PROCESS SPECIFICATION DEPARTURE	Originator: T. Nguyen Supervisor: B. Grant Manufacturing: W. Plagemann Quality: A. Cooper Materiel: A. Cooper Engineering: M. Reddy	PSD NUMBER 6-6 Page 1 of 8	PROCESS SPEC NO. BAC5058
Implementation of this departure is: <input type="checkbox"/> OPTIONAL - May be implemented at discretion of affected organization. <input checked="" type="checkbox"/> MANDATORY - Must be implemented as noted below.		PROCESS SPEC TITLE RIVETING IN TITANIUM	
REASON: CHANGE 'ON MODEL' BLOCK. SEE REASON BELOW.		RELEASE DATE 28-JUN-2008	
SUBCONTRACTOR(S) AFFECTED ALL	ON MODELS ALL COMMERCIAL AIRPLANES AND DERIVATIVES THEREOF	MFG DEPTS OF DIV BELOW AFFECTED ALL BCA AND SUPPORTING

THIS PSD SUPERSEDES 6-4

REASON: BAC5058 Process Spec. Compliancy Issues & Resolutions for all BCA Aft Pylon Heat Shields. Revise Table I, Hole Diameter, for size 3/8 from 0.279 to 0.379. Revise Table II to add 7/32 inch and 9/32 inch oversize rivets, FL 1 and FL 2 to Table II. Change rework requirements to allow select use of oversize rivets without Engineering approval.

PROCESS SPECIFICATION DEPARTURE	PROCESS SPEC TITLE RIVETING IN TITANIUM	PSD NUMBER 6-6 PAGE 2 of 8	PROCESS SPEC NO. BAC5058
---

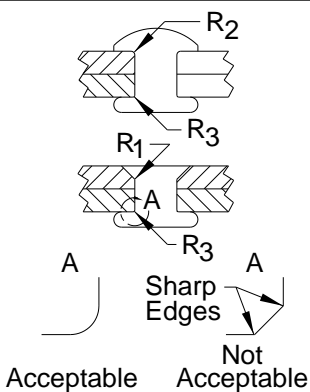
Revise Section 8.1.

- a. Hole sizes for titanium rivets shall conform to Table I.
- b. Hole radii for 6Al-4V titanium rivets shall conform to Table I. For other rivets, the holes may have a radius in accordance with Table I or a chamfer in accordance with Table V when necessary to allow head seating or to remove burrs at the hole entrance or exit. When radiusing the hole exit as shown in Table I, R, Section A, emphasis on a smooth transition rather than a true radius is intended. The transition shall be smooth with no sharp corners or edges.

Sharp edges will cause the rivet to crack.

FIGURE X - DRIVEN BUTTON REQUIREMENTS FOR DOUBLE FLUSH RIVETING

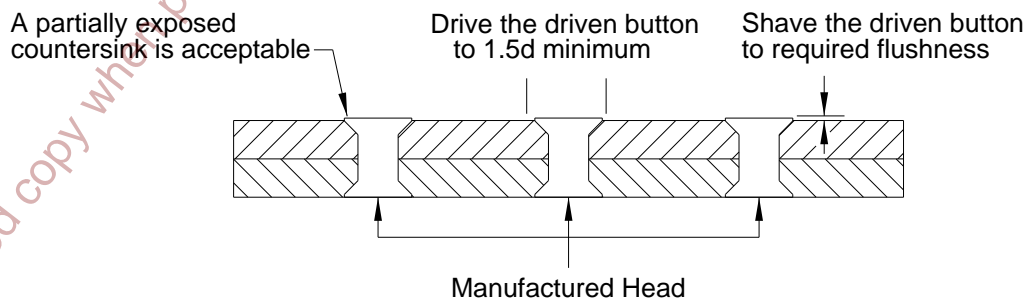
- b. Unless otherwise specified by the drawing, flushness limits after driving shall be in accordance with Table VIII. The rivet head shall not be below flush except for dome head rivets as noted in Figure 1.
- c. When shaving 100 degree countersunk head rivets, surface flushness requirements shall be in accordance with Table VIII.
- (1) Head protrusion shall not exceed H in Table VIII after driving and prior to shaving.
- (2) Head diameter shall not be less than D in Table VIII after shaving.
- d. The manufactured heads of [BACR15CE](#), [BACR15DS](#) and [NAS1097](#) rivets shall not be shaved or modified (e.g., sanding, grinding, etc.) to meet the flushness requirements without Engineering approval. For double flush riveting applications, driven (formed) buttons of these rivets may be shaved. The driven buttons for double flush riveting shall meet the conditions described in Figure X.

- x. When a flush head rivet is driven double flush, the countersink depth setting for the driven button shall be the same for the manufactured head. The minimum driven button diameter shall be 1.5d as note in Section 8.4.2, Figure X.
